Marion County

Development Review Committee

Meeting Agenda

Monday, May 4, 2026

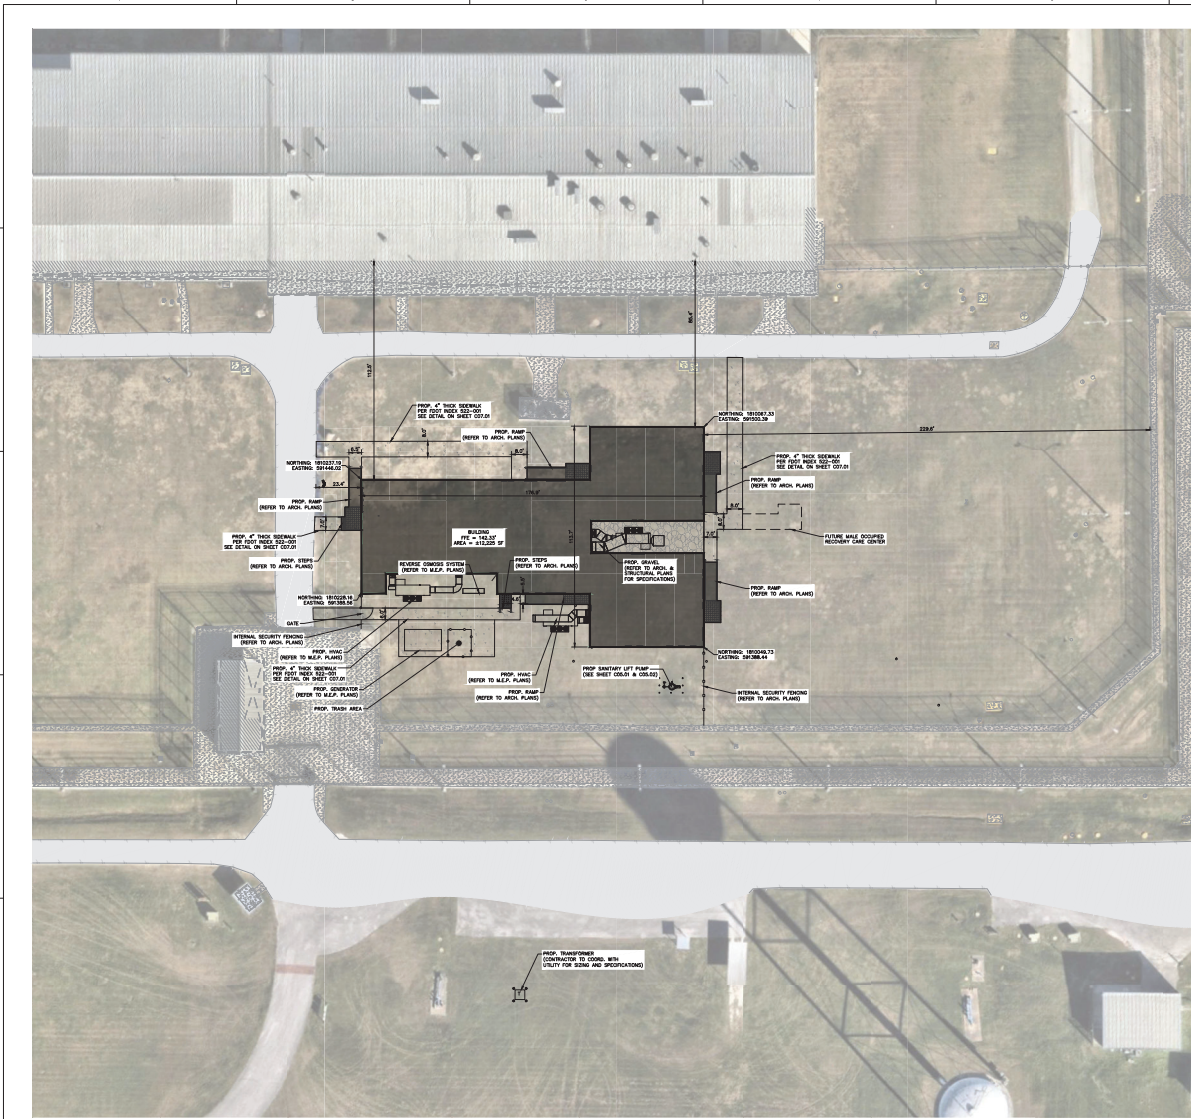
Comment

Please submit waiver from landscape requirements
